BROOKS RECYCLED WATER PUMP STATION UPGRADES PROJECT
Solicitation Number: CO-00657
Job No.: 21-8601

ADDENDUM 2
September 27, 2023

SAN ANTONIO WATER SYSTEM
BROOKS RECYCLED WATER PUMP STATION UPGRADES PROJECT
PROPOSED SEQUENCING PLAN

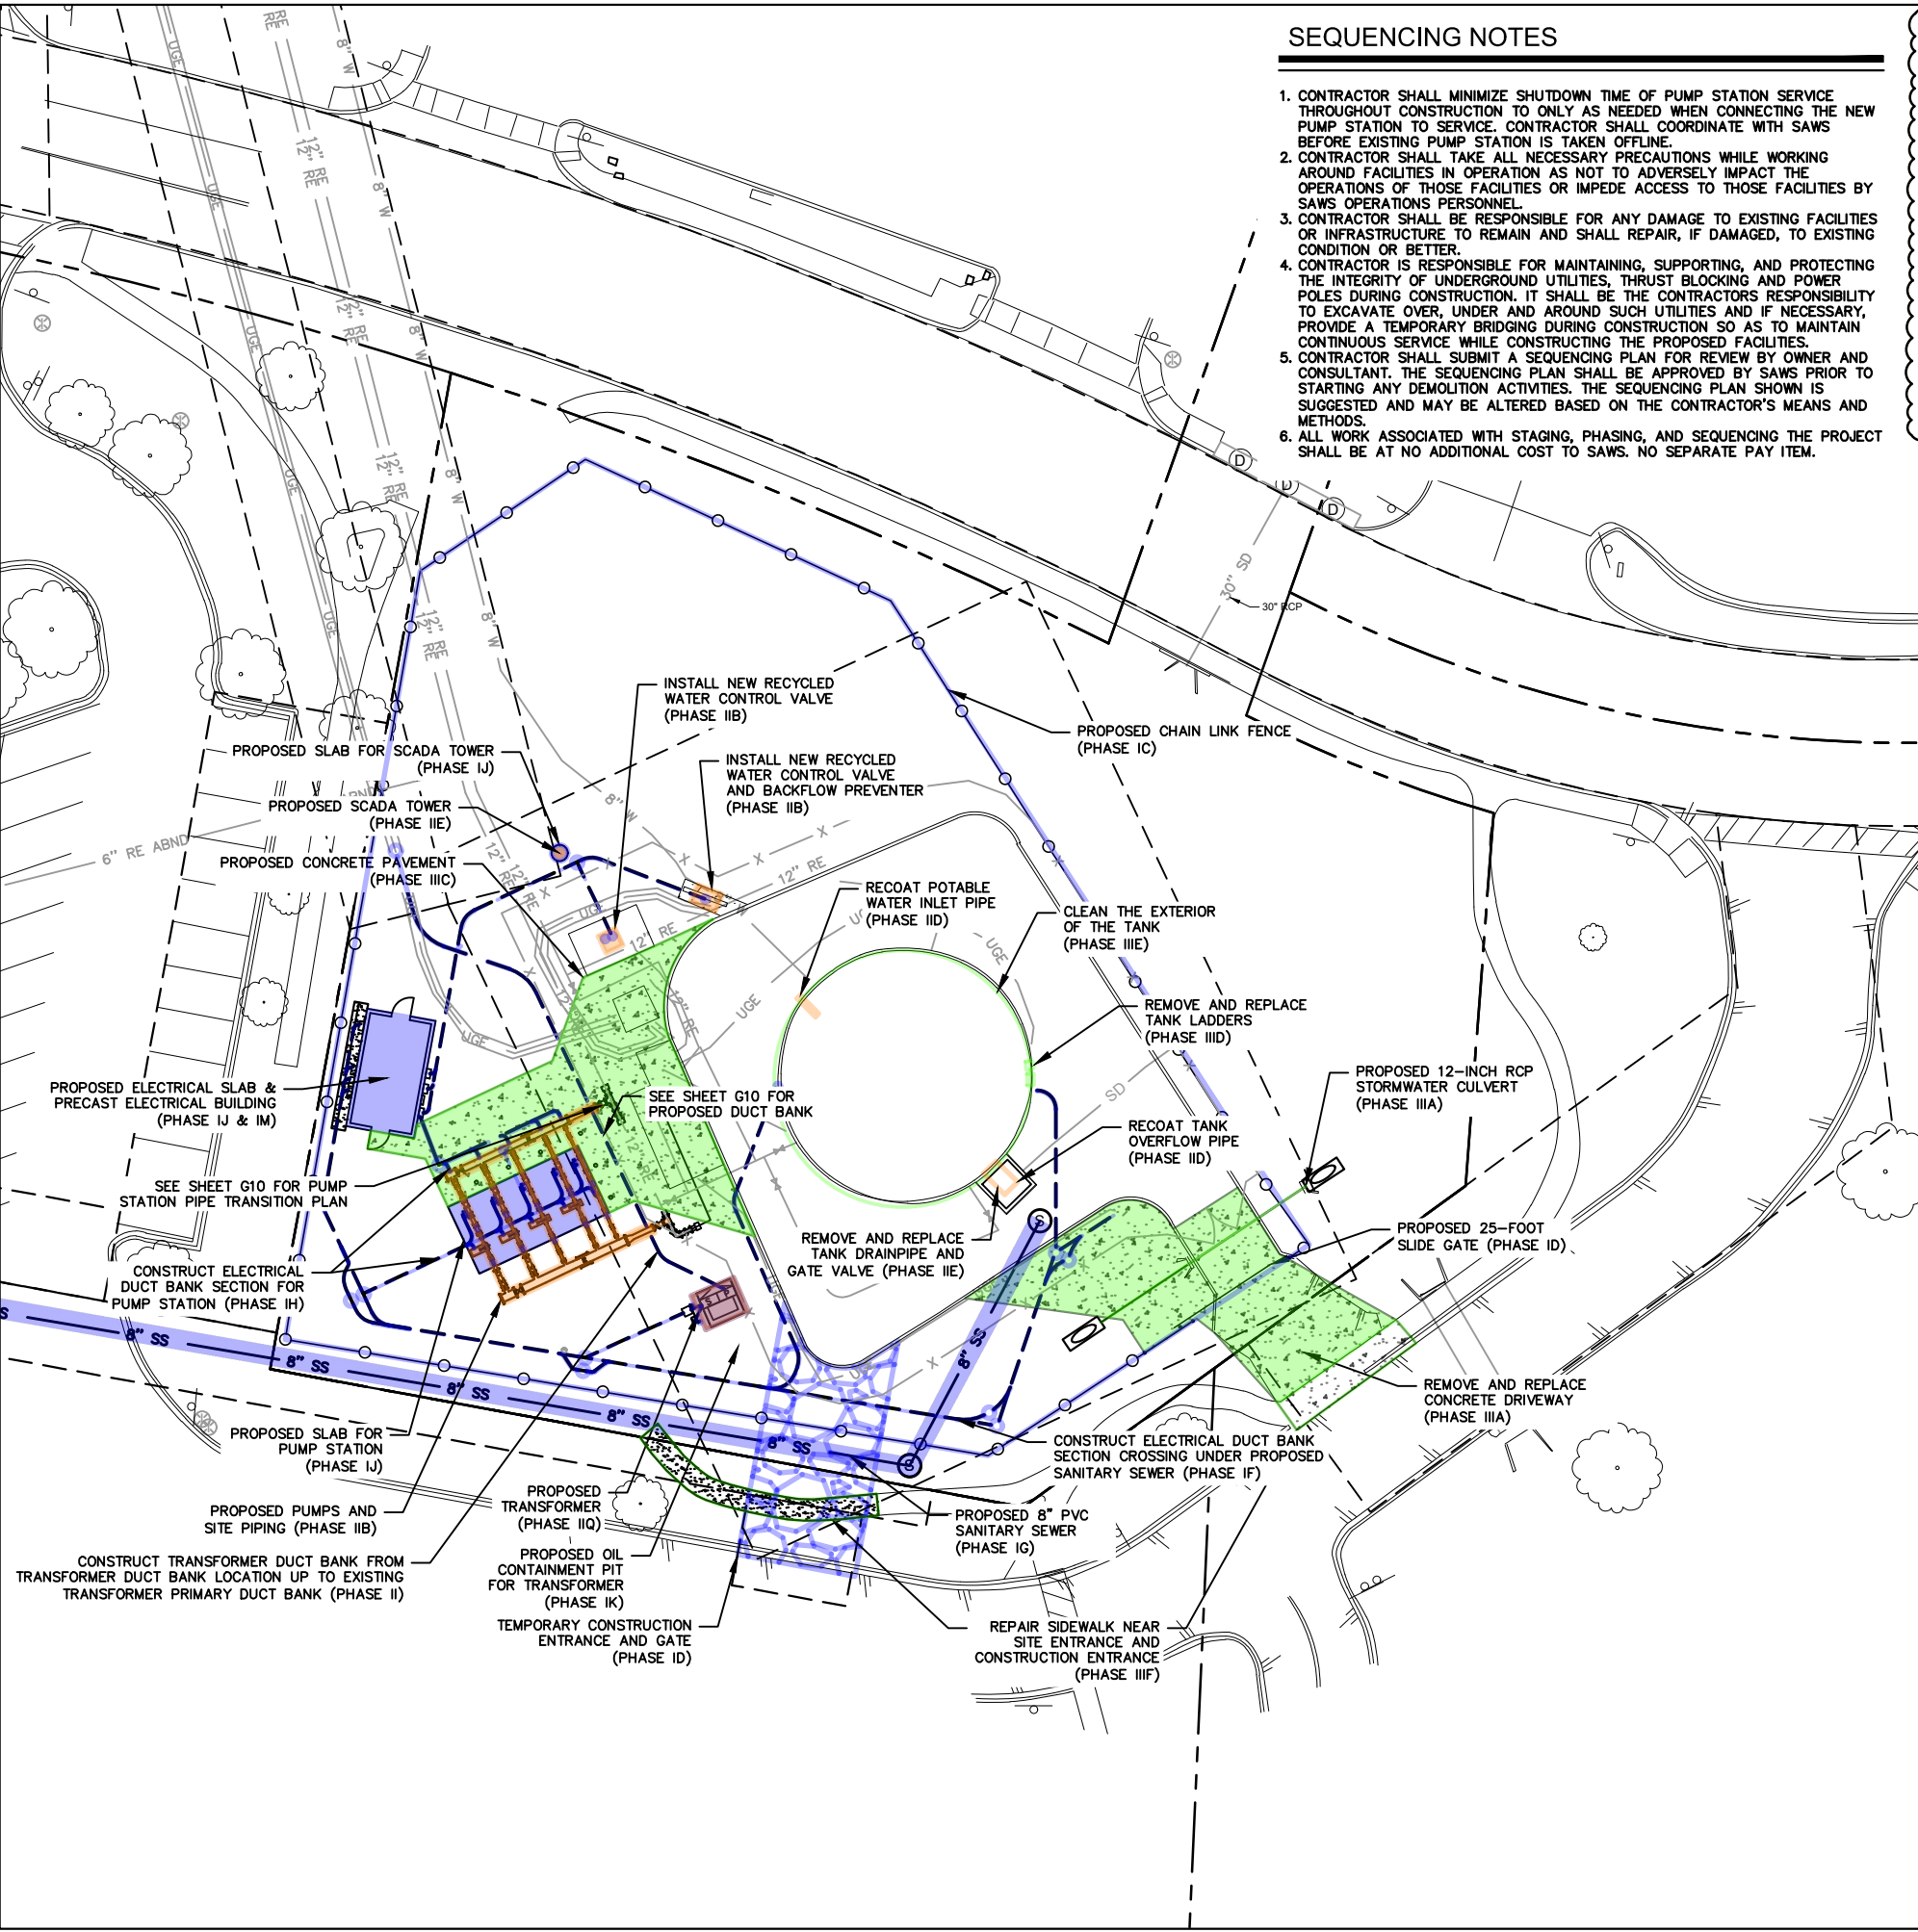
- 12. Question: Sheet G9 states to install a new recycled water control valve and backflow preventer. Sheet C1 points to the same location and states altitude valve and slab to remain. Please advise.**

Response: The altitude valve will be replaced and the slab will remain. Please refer to Changes to the Plans No. 2 of this Addendum.

DRAWING NO.
C3

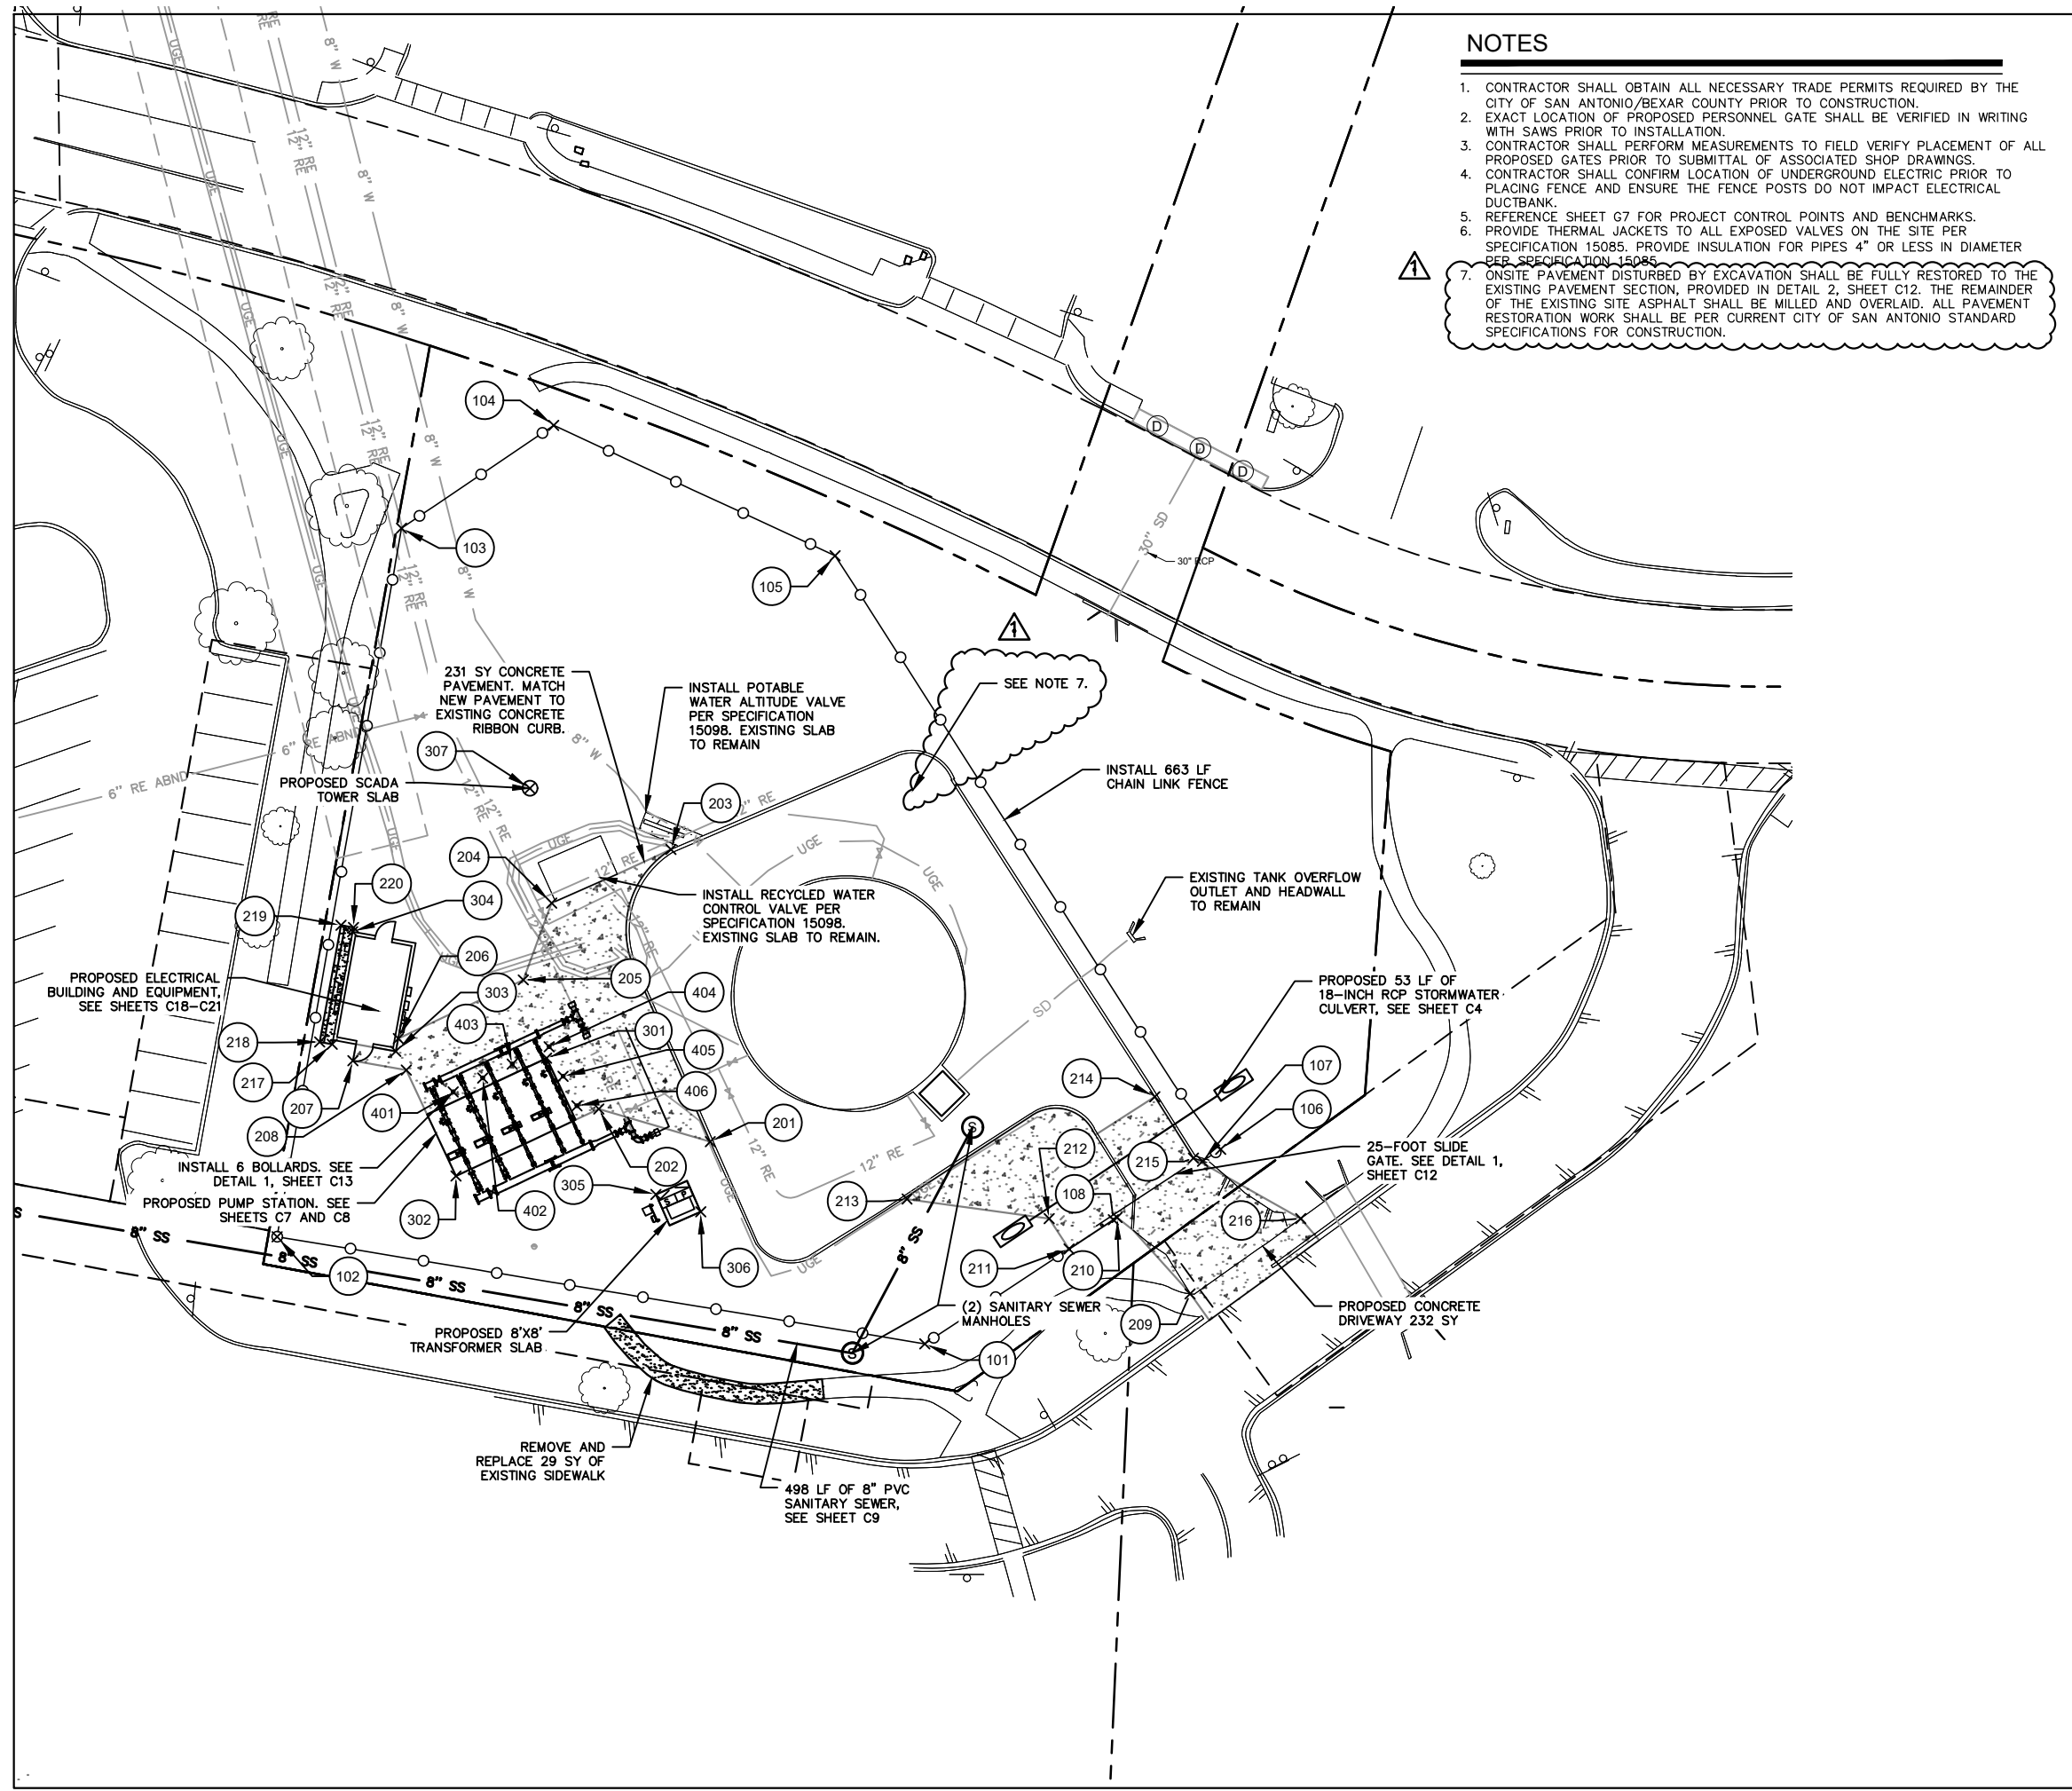
3. Question: Is a location and number of required bollards available?

- 7. Question: Existing pavement and entrance at site have asphalt paving, drawings are calling for concrete paving. Please confirm this is desired?**

- 15. Question: There is a lot of asphalt replacement but no asphalt section details to go off of (ex. A stone layer, tie in, etc.) Please provide details for the asphalt.**

Response: Six (6) bollards are required. Please refer to Sheet C3 for bollard locations.

Response: Pavement at entrance will be concrete pavement. Existing asphalt pavement will be milled and overlaid. Please refer to Changes to the Plans Nos. 3 and 5 of this Addendum.

Response: Clarification has been added to Sheets C3 and C12 regarding asphalt replacement and the existing pavement section. Please refer to Changes to the Plans Nos. 3 and 5 of this Addendum.

- ON-SITE PAVEMENT DISTURBED BY EXCAVATION SHALL BE FULLY RESTORED TO THE EXISTING PAVEMENT SECTION, PROVIDED IN DETAIL 2, SHEET C12. THE REMAINDER OF THE EXISTING SITE ASPHALT SHALL BE MILLED AND OVERLAID. ALL PAVEMENT RESTORATION WORK SHALL BE PER CURRENT CITY OF SAN ANTONIO STANDARD SPECIFICATIONS FOR CONSTRUCTION.

DRAWING NO.
C9

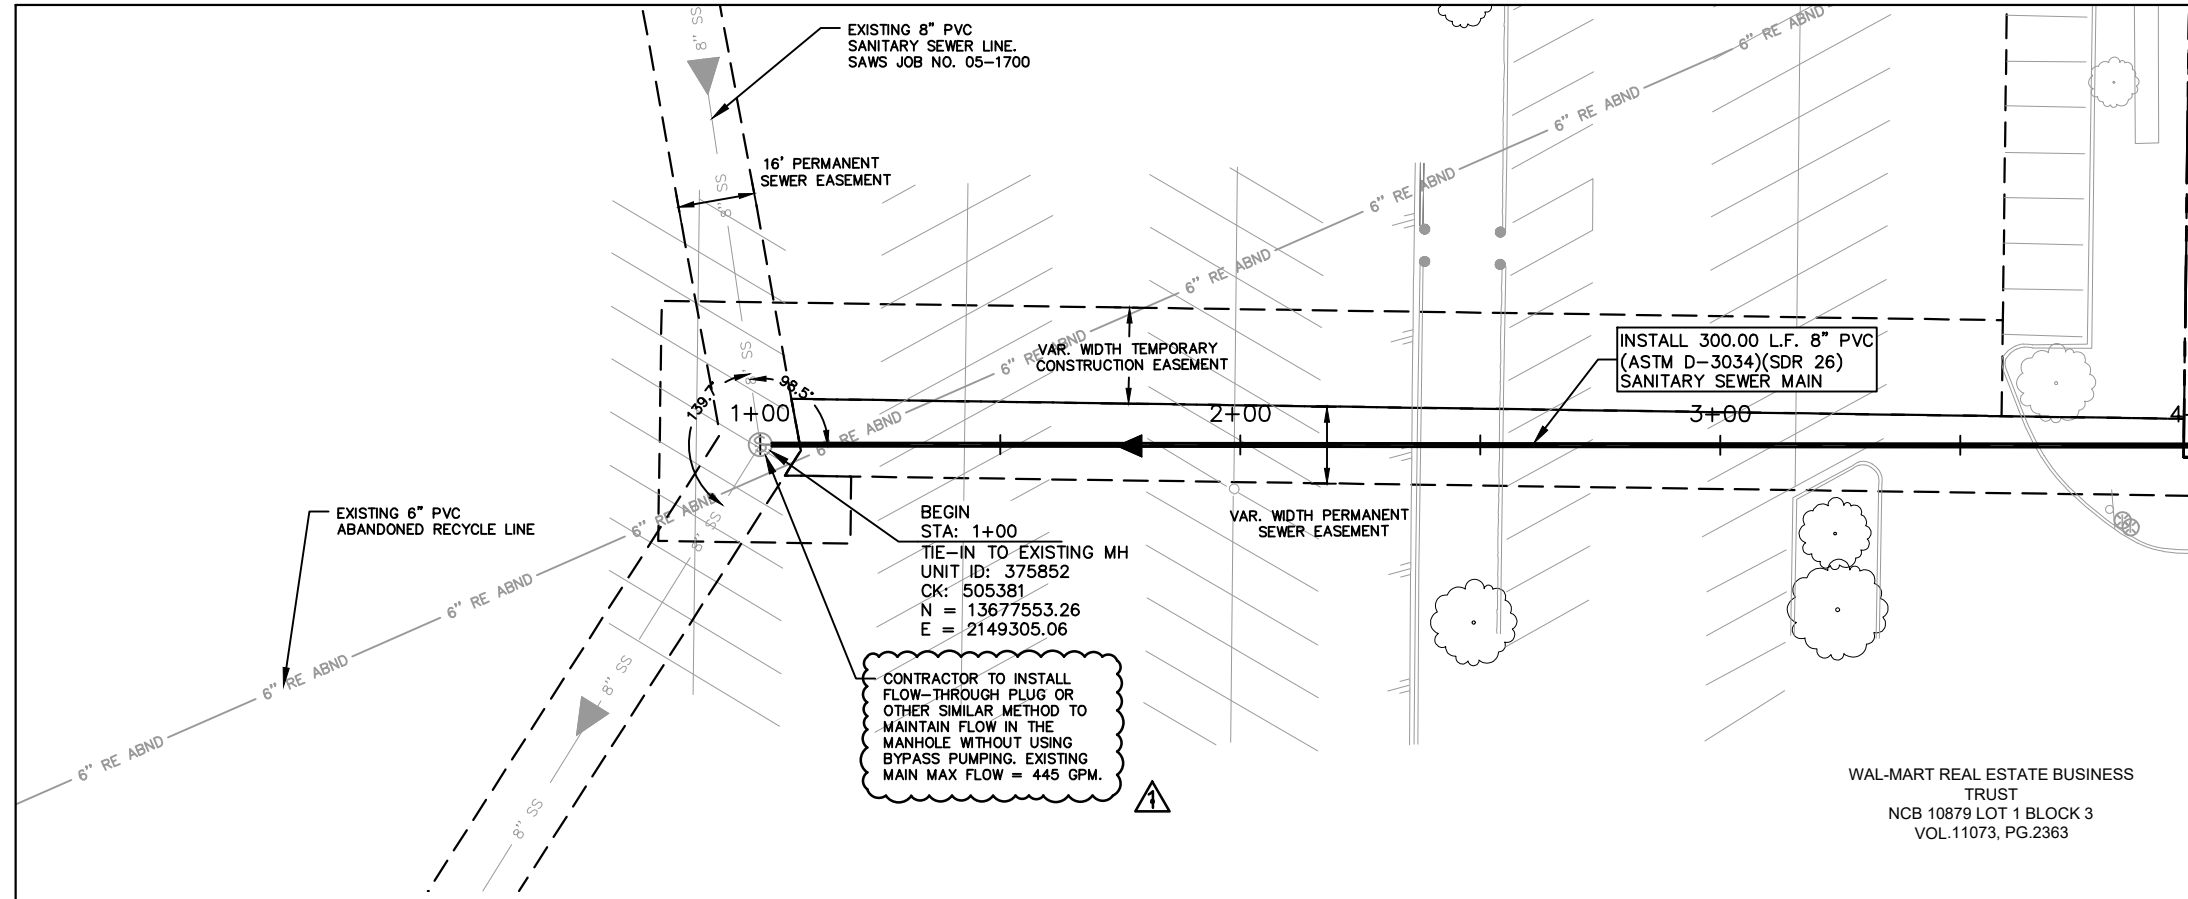
- 11. Question: What flowrate is existing manhole receiving currently?**

- 13. Question: There is a unit price for flowable fill, but we have not seen in on the drawings, please clarify where this is to be used.**

Response: Maximum flow rate on existing main is 445 GPM. Please refer to Changes to the Plans No. 4 of this Addendum.

Response: Flowable fill is to be installed as secondary backfill between stations 1+00 and 3+65 of the proposed sanitary sewer main. Please refer to Changes to the Plans No. 4 of this Addendum.
